## Access Compliance Report Public Rights-of-Way (Curb Ramps)

Intersection ID: 28605Main Street:FOX\_THORNE\_DRCross Street:MT\_HOLLY-HUNTERSVILLE\_RDLocation:NWADA ID: 66F9BC17962ERamp Type:PerpInitial Pass/Fail:FailOverall Compliance:NoSeverity Score:22.5

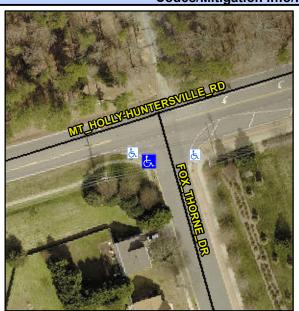
Field Measurements/Component Compnance						
	Compliance Description		Data	Compliance Description		Data
	N/A	Ramp Length (in)	46.5	No	Ramp Slope (%)	11.6
	No	Ramp Width (in)	36.5	No	Ramp XSlope (%)	4.0
	N/A	Flare Type LT	N/A	N/A	Flare Type RT	N/A
	N/A	Flare Slope LT (%)	N/A	N/A	Flare Slope RT (%)	N/A
	N/A	Flare Traversable LT?	N/A	N/A	Flare Traversable RT?	N/A
	N/A	Landing Length (in)	N/A	N/A	DWS Provided?	N/A
	N/A	Landing Width (in)	N/A	N/A	DWS Contrast?	N/A
	N/A	Landing Slope (%)	N/A	N/A	DWS Length (in)	N/A
	N/A	Landing X Slope (%)	N/A	N/A	DWS Full Width?	N/A
	N/A	Landing Curb? (Y/N)	N/A	N/A	DWS Offset (in)	N/A
	N/A	Shared Landing?	N/A			
	N/A	Gutter Ponding?	Yes	N/A	Gutter Slope (%)	N/A
	N/A	Gutter Lip Ht (in)	N/A	N/A	Gutter X Slope (%)	N/A
	N/A	Painted X Walk1?	No	N/A	Painted X Walk2?	N/A
		X Walk 1 Direction	To S		X Walk 2 Direction	N/A
	N/A	X Walk 1 Width (in)	N/A	N/A	X Walk 2 Width (in)	N/A
		X Walk 1 Slope (%)	4.6		X Walk 2 Slope (%)	N/A

X Walk 1 X Slope (%)	3.1		X Walk 2 X Slope (%)	N/A
	N/A	Ramp inside XWalk1?	N/A	N/A	Ramp inside XWalk2?	N/A
		Road Slope (%)	N/A	N/A	Clear Space?	N/A
		Road X Slope (%)	N/A	N/A	Clear Space to XWalk (in)	N/A
	N/A	Any Obstructions?	N/A	N/A	Storm Grate/Utility Hazard?	N/A
		Obstruction Type			Storm Grate/Utility Type	
			N/A			N/A
				Yes	Surface Condition? (G/P)	Good

Total Cost: \$ 1850.00
